PROJECT NAME: RD PLAZA WAREHOUSES

PROJECT NUMBER: 2024010064

APPLICATION: MAJOR SITE PLAN #31078

A MARION COUNTY MAJOR SITE PLAN
FOR
RD PLAZA WAREHOUSES
MARION COUNTY
Title Sheet

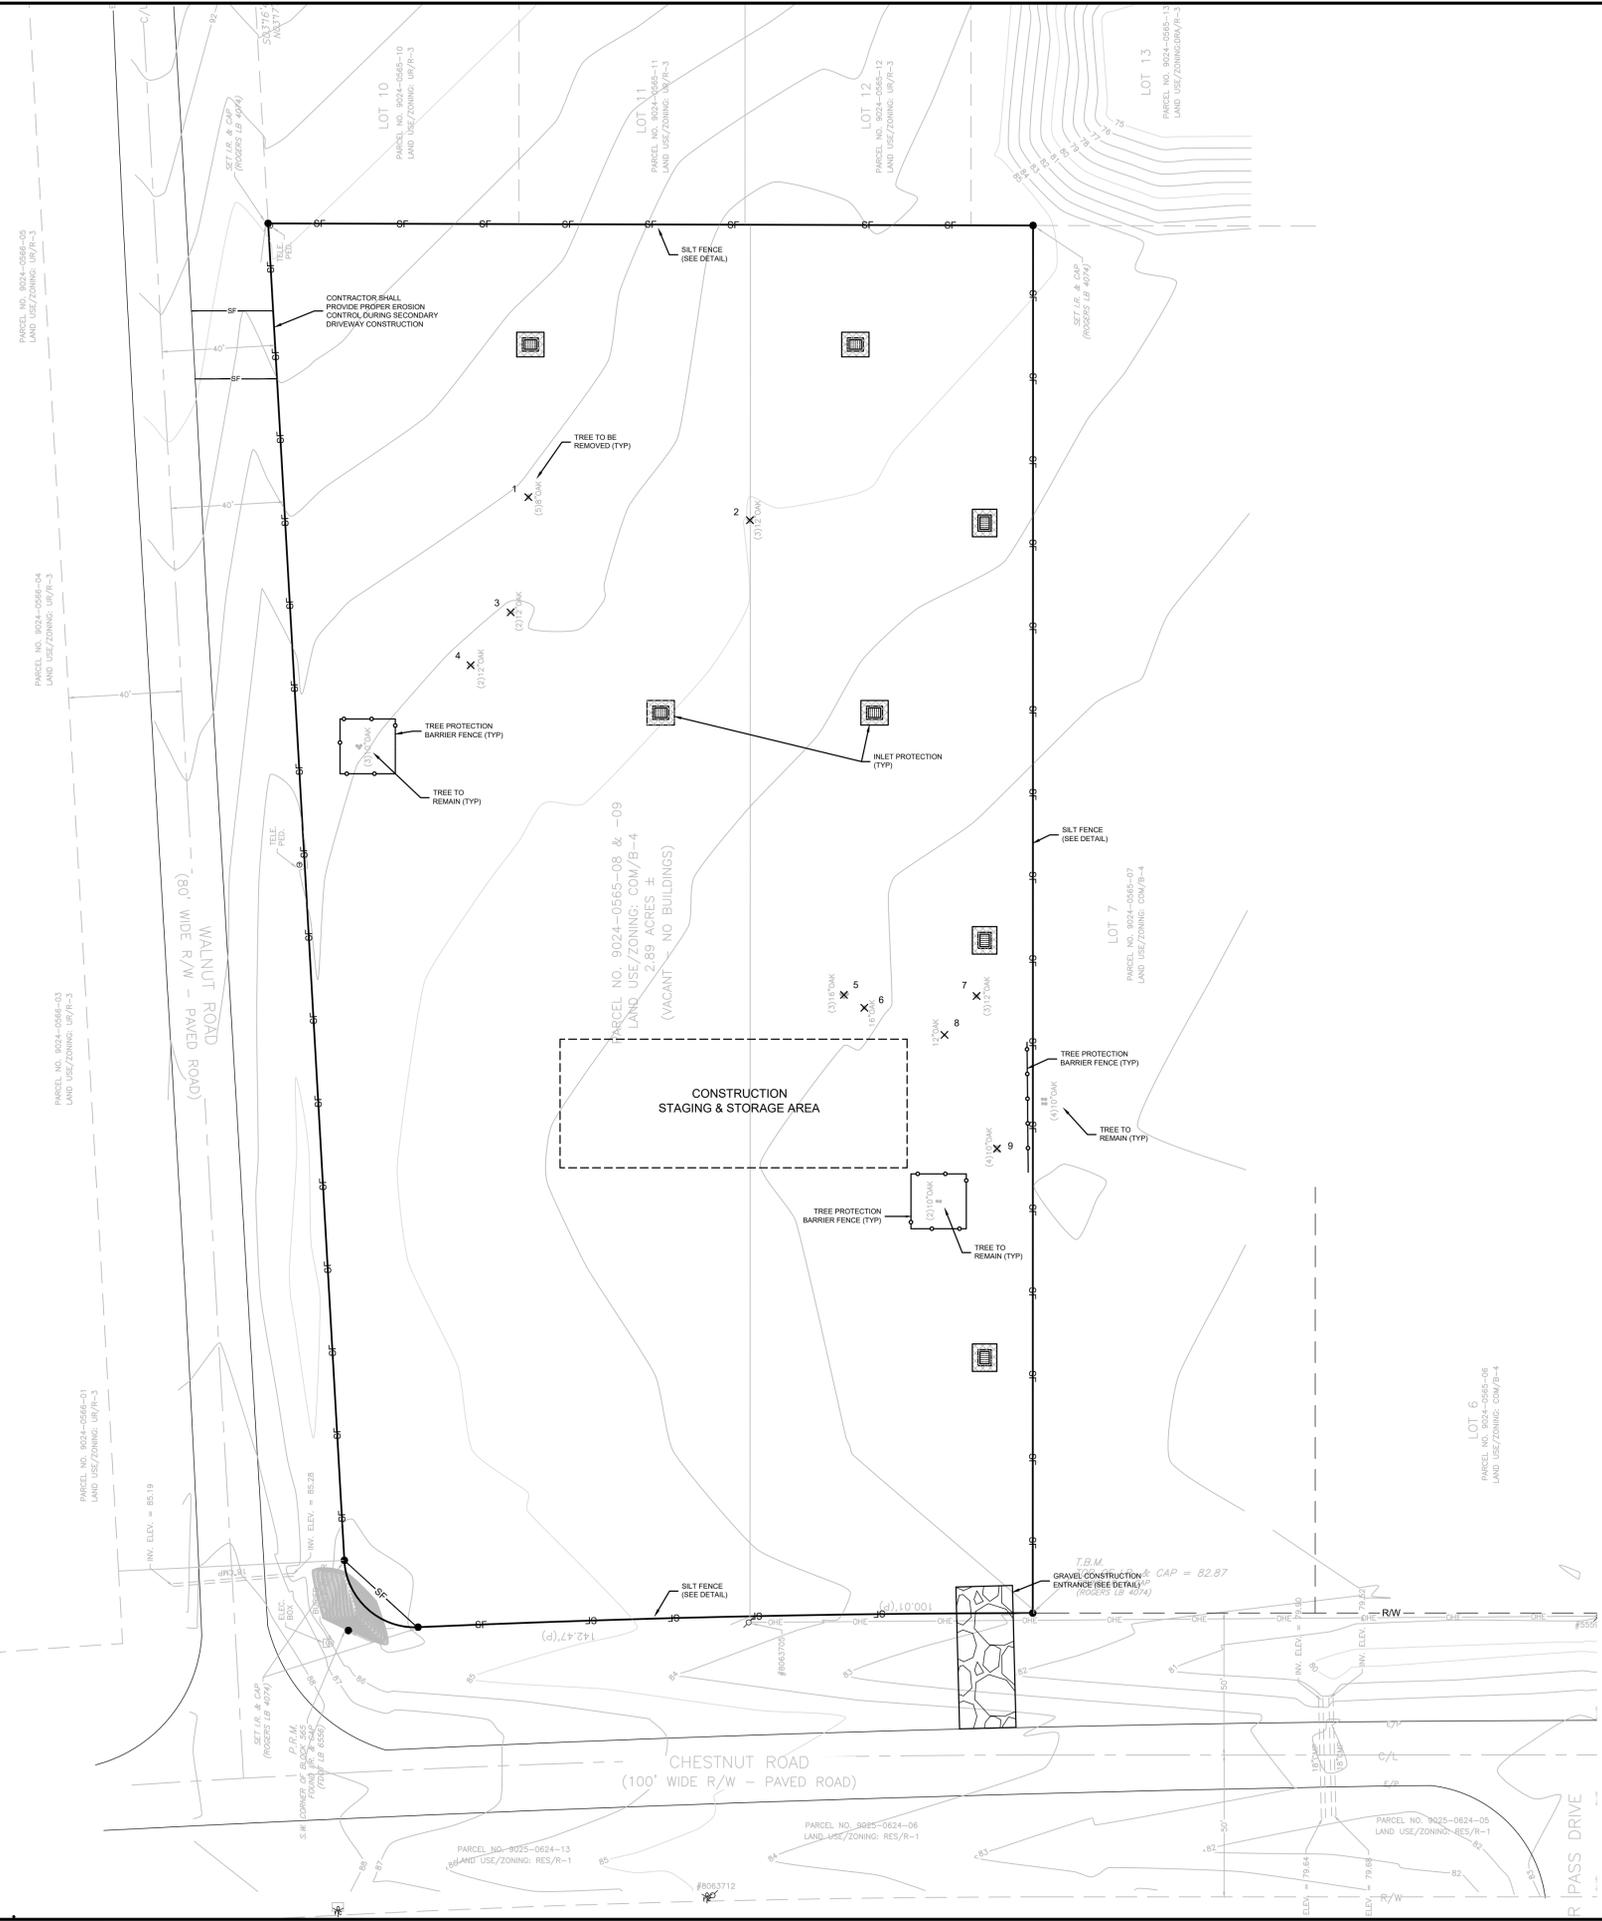
- 19 DEPARTMENT: ENGDRN - STORMWATER REVIEW
REVIEW ITEM: 2.12.4.L(9)(b) - Data Block (Impervious Area)
STATUS OF REVIEW: NO
REMARKS: Please provide data block on the cover sheet detailing the existing impervious & pervious area in SF, ac, and %. Please include any offsite drainage to your site in the data block.

- 37 DEPARTMENT: 911 - 911 MANAGEMENT
REVIEW ITEM: 2.12.8 - Legal description matches boundary on plan
STATUS OF REVIEW: NO
REMARKS: Sheet C001 has the incorrect Section & Township as 7/17, it should be 13/16.
